DRAINAGE OF THE NEW PALACE AT WESTMINSTER.

Mr Austin's Report.

Mr Barry's Reply.

Mr Austin's Observations upon the Remarks of Mr Barry on the Report upon the Drainage of the New Palace at Westminster.

Block Plan of the New Palace at Westminster.

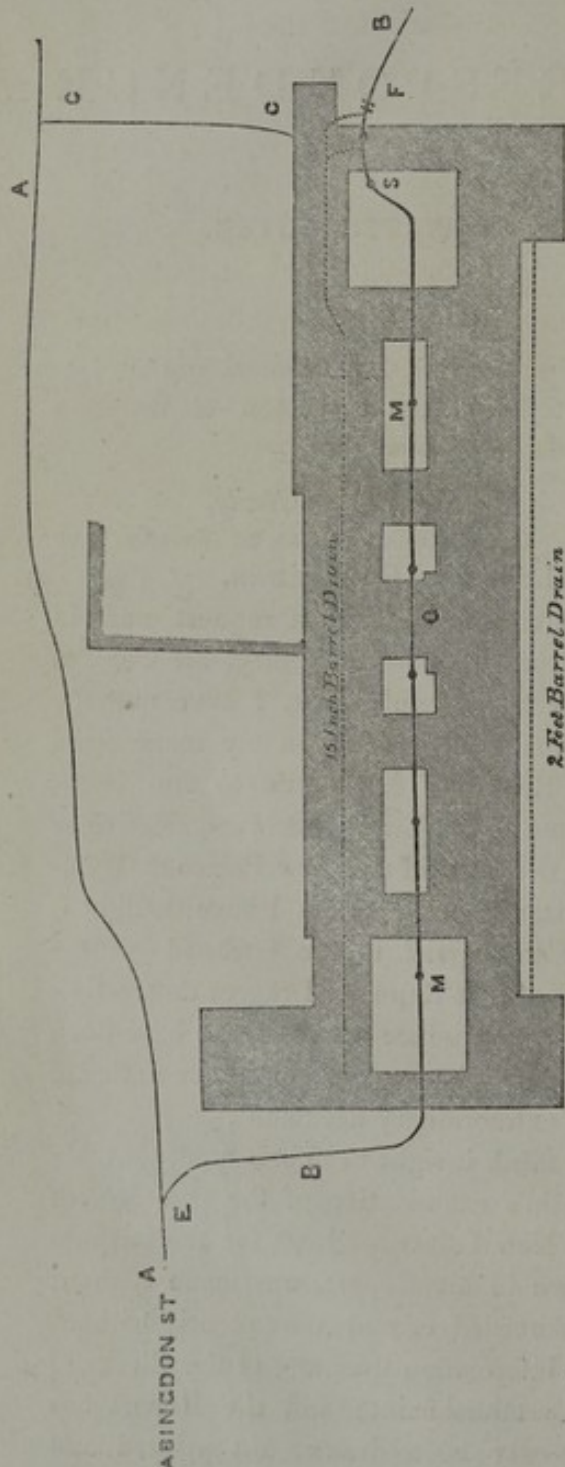
1. The sewer A A from Abingdon street to the River at Westminster bridge was constructed to receive the sewers from the New Palace, at the instance of the late Westminster Commissioners of Sewers. The private sewer B B traverses the whole length of the new buildings, and it would appear that it was intended originally to have its outfall at each end into the public sewer just described. The northern arm

3. There are six man-holes to the main sewer through the New Palace, marked M on the plan, there being one situated in each court-yard. The accompanying section exhibits the form of the sewer. It is five feet six inches in height by three feet in width.

1. Both the sewers A A and B B were constructed in 1837 and 1838. The northern arm C C was cut off in 1842 on the unexpected discovery of an old sewer passing through the abutment of Westminster bridge, and communicating with the Bridge-street sewer near its outfall into the Thames, by which an additional depth of five feet six inches was obtained for the outfall of the Palace drains,

3. These man-holes are, and always will be, kept closed and air-tight, except when occasionally opened for repairs on the examination of the main sewer.

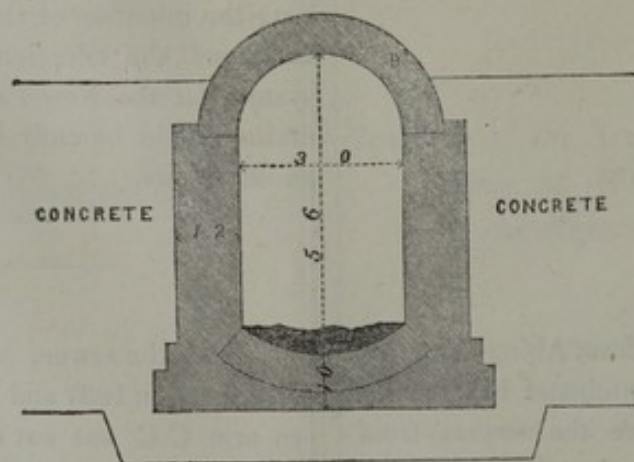
5. The accompanying sketch, without pretending to architectural precision, is an attempt to explain this circumstance, and exhibits the true relation of the level of the sewer with the vaults around at this point.

5. The following sketch of the vaults, although highly graphic and amusing, is altogether incorrect: the sewer is there represented as being in the vaults of the building, the several vaults being shown to be about 22 feet wide and 15 feet high;

whereas, in fact, it is placed, not in the vaults of the building, but in three arched spaces under an open gateway, each of which is not more than 13 feet wide and 6 feet high, and intended ultimately to be filled in around the sewer with concrete.

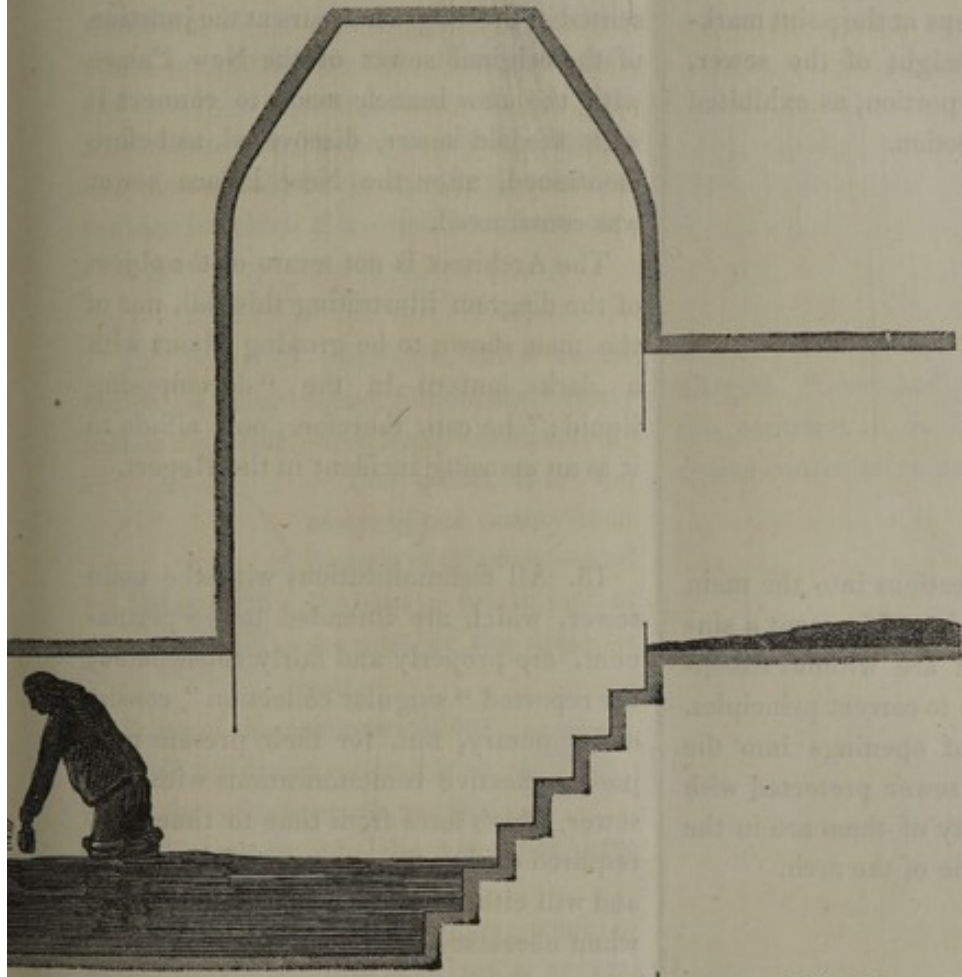
11. Fig. 1 exhibits the depth of the foul deposit at the Abingdon-street end of the sewer, and fig. 2 the depth of the decomposing liquid and solid matter at the northern end of the sewer. At the latter point, immediately beneath the Speaker's house, the noxious gas was bubbling and hissing from the surface as if a great fire were below. The

11. Whatever foul deposit may have been found in the Abingdon-street junction of the sewer is wholly due to the foul state of the public sewer in Abingdon street.

The decomposing liquid and solid matter shown in Diagram No. 2, at the northern end of the New Palace sewer, is due also to the foul condition of the public sewer in Bridge street, and to the periodical stoppage of the Palace drainage during the rise of the tide as before alluded to; at low water the whole of the solid matter and decomposing liquid would pass off if the public sewer were freed from the accumulation of solid matter that has been permitted to collect in it.

The Diagram, fig. 2, can only be true as showing the amount of it impounded at a time when the outfall flap was closed.

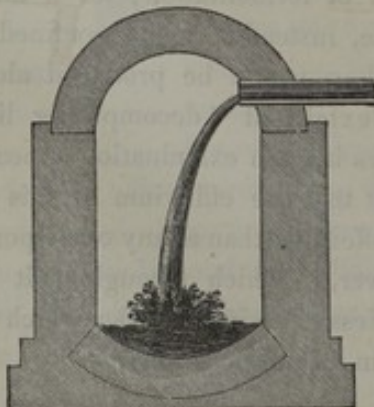
12. This portion of the sewer descends suddenly by seven steps at the point marked S, and is the full height of the sewer, lower than the other portion, as exhibited in the longitudinal section.

12. The sudden fall in the sewer represented in the diagram occurs at the junction of the original sewer of the New Palace with the new branch made to connect it with the old sewer, discovered, as before mentioned, after the New Palace sewer was constructed.

The Architect is not aware of the object of the diagram illustrating this fall, nor of the man shown to be groping about with a dark lantern in the "decomposing liquid;" he can, therefore, only allude to it as an amusing incident in the Report.

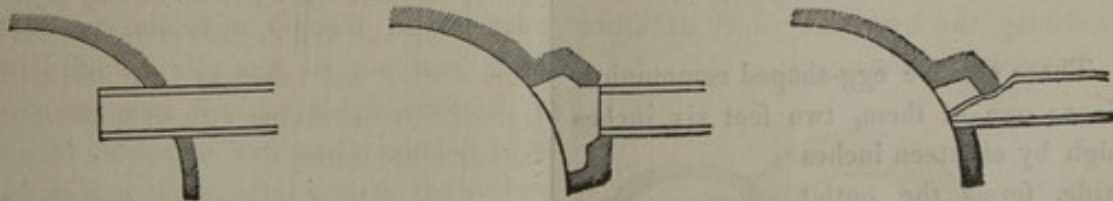
15. Some of them are brick barrel drains, of nine, twelve, fifteen, and twenty inches diameter, wretchedly constructed.

The outlet into the sewer of one twenty-inch drain is of this form—and is about a fourth part of the area of the drain itself.

15. The brick barrel drains are not, as alleged, "wretchedly constructed." On the contrary, it is impossible that such drains can be more perfectly constructed.

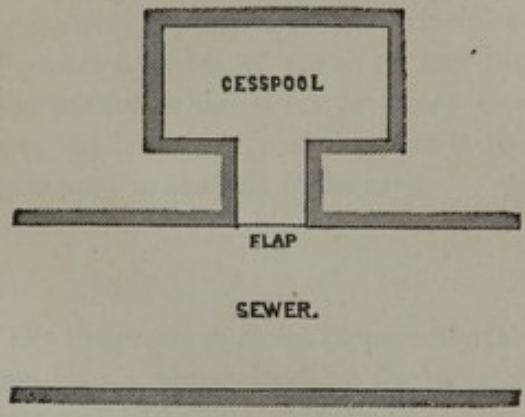
Some are obstructed at the outlet by brick and lumps of cement, one to the extent here shown:—

PLAN OF BASEMENT
OF PART OF
The New Palace at Westminster.

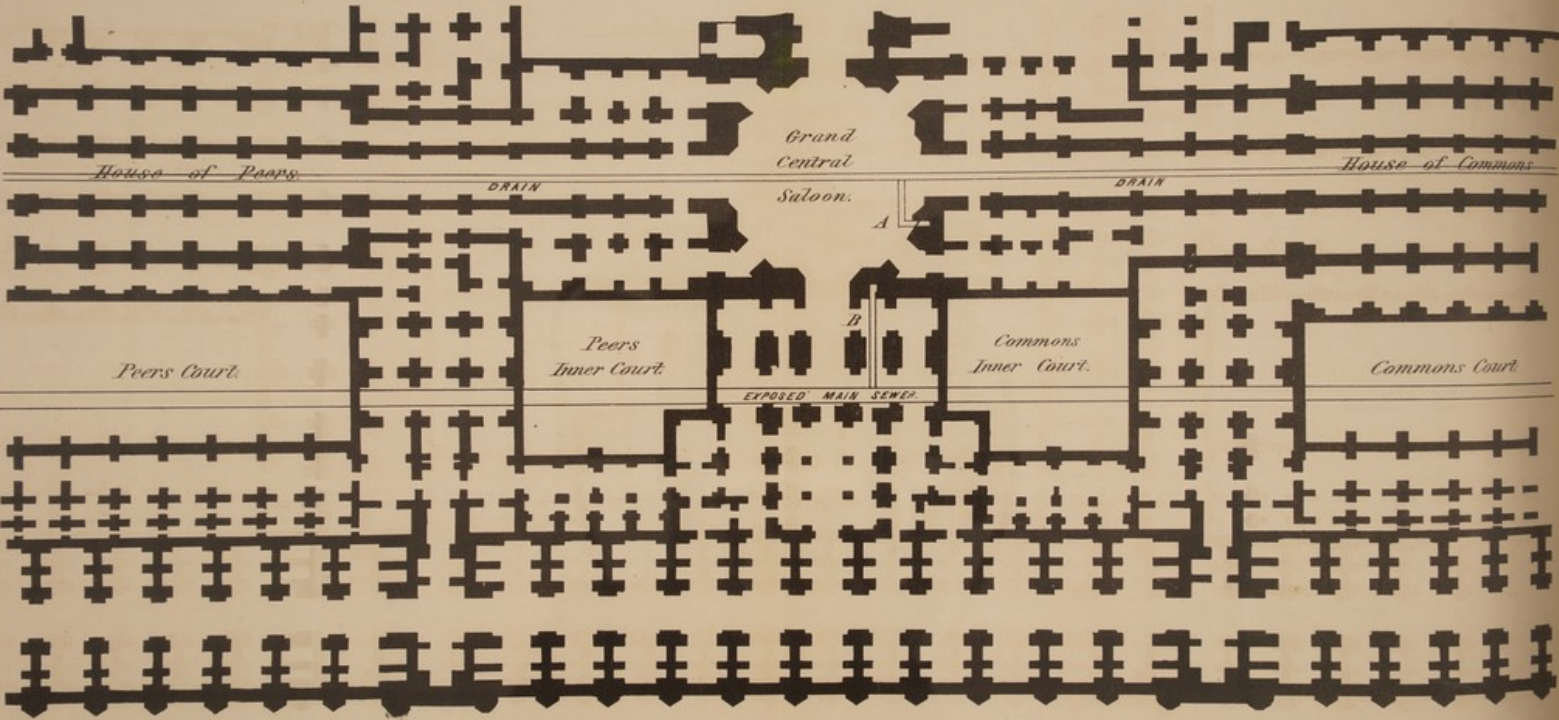
It would appear to matter little by what term these portions of the basement of the building should be called; the fact being, that there exists, as shown on the accompanying plan, *a perfect communication throughout the buildings by their means*; that the whole of these works, whether of "vaults" or "arched spaces," appears to be of precisely similar construction, and have, I am informed, always been known and spoken of before Committees, and on the works, without distinction, as "vaults;" and that although open gateways may exist immediately above this part, that the exposed sewer itself passes within *about 12 yards from the basement of the Grand Central Saloon connecting the Houses of Lords and Commons*; with the vaults or arched spaces of which there is perfectly open communication, and through which I have myself passed more than once to the sewer.

That, agreeing with Mr Austin in thinking it immaterial whether the main sewer of the Palace passes through "vaults" or "arched spaces," I have to observe that the term "arched spaces" was made use of by me to correct, in some degree, the false impression created by the exaggerated description and pictorial illustrations of them contained in his Report, from which it might be inferred that the main sewer had been constructed in spacious vaults under the entire building, instead of passing, as it does, through comparatively small and insignificant spaces, at intervals, and under open gateways, intended to be filled up solid with concrete. It matters not, therefore, under such circumstances, whether the sewer passes, as he states, within "about twelve yards from the basement of the Grand Saloon connecting the Houses of Lords and Commons," or immediately under it.

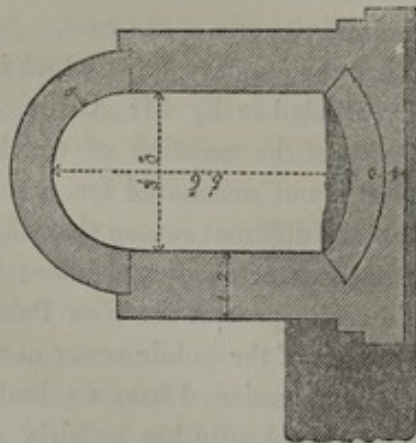
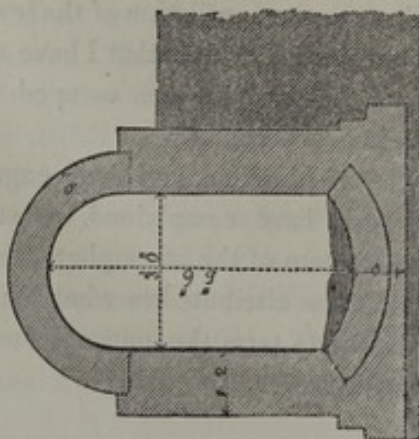
It would be inferred from this statement that the summit level is the point where the sewer is the most exposed, but it is not so. The level of the sewer at the summit, with relation to the vault-floor level, is correctly drawn in section, in the illustrative sketch in the second page of the Report, where the opening into the vaults is shown. Further on, however, and immediately opposite to the opening above referred to, leading to the basement of the Grand Central Saloon, the top of the sewer is as much as 5 feet above the vault-floor level, leaving little more than a foot below that level to the invert, instead of 3 feet 6 inches, as stated by Mr Barry.

Fig. 1 is a section showing the relation of the sewer with regard to the vault-floor at the summit level, quoted by Mr Barry. Fig. 2 is a section as it exists opposite the basement of the Grand Central Saloon.

That the whole of the statements in my remarks upon Mr Austin's Report, as to the levels of the main sewer, and the dimensions of the arched spaces through which it passes, are correct, although attempted to be falsified by Mr Austin; and that the inference which he deduces from one of them, as to the position of the summit level, is not warranted.

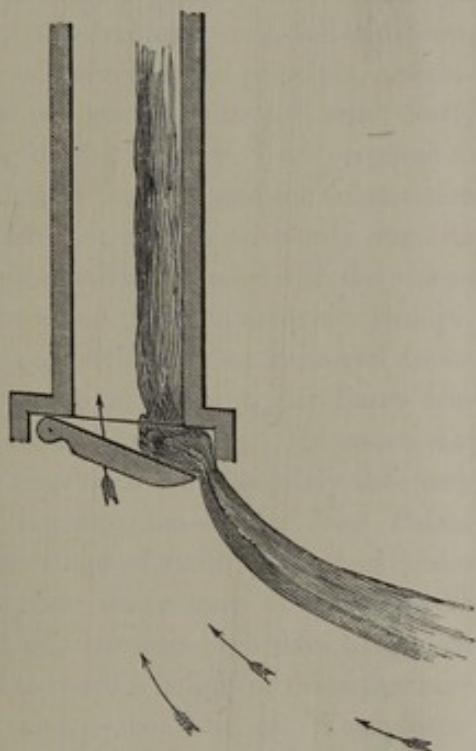
Cut off from all possibility of ventilation, with constant foul deposit therein, the whole length of this sewer must shortly become nothing better than a vast retort, capable of holding some 15,000 cubic feet, in which the foulest gases will be perpetually generating and escaping in a concentrated form into the buildings.

It is a fallacy to suppose that flaps, placed at the mouths of the drains, communicating with the sewer, will at all times prevent the escape of this dangerous miasma. Even supposing that the contact of the surfaces could at all times be perfectly preserved, every time that a discharge takes place, and the flap is raised, an opening is formed through which the foul and pent-up gases will rise and escape into the building as indicated in this section.

That the flaps to the branch drains are not fixed for the purpose of preventing the escape of foul air into the building, as Mr Austin seems to suppose, although they may contribute to that object; but that other and perfectly effective means are provided for that purpose, of which he appears to be ignorant. All Mr Austin's reasoning, therefore, upon these flaps and their admission of foul air into the building falls to the ground.
